URBAN DESIGN COMMISSION

DESIGN RECOMMENDATION

71-72 Union Square

OCTOBER 8, 2020

Option #1 (multiple views)

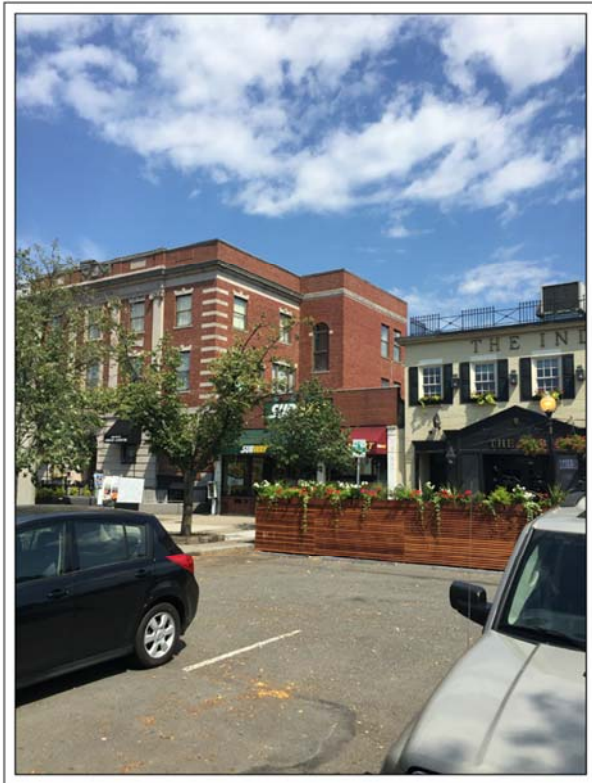
The Commission voted unanimously (3-0) to recommend façade design option #1. The Commission voted unanimously (3-0) to recommend that the Planning Board consider design guidelines 6.2.12.a.ii and 6.2.12.a.iv (with specific attention to the building's pilasters) as a priority for the proposed building. The Commission voted unanimously (3-0) that all of the CC5 design guidelines have been met to their satisfaction by the Applicant's preferred façade design option and preferred ground floor elevation. No recommendation was provided for any modifications to the preferred façade design option. The commission discussed some façade design details, such as the buildings signage and canopy, but did not provide any recommended changes.
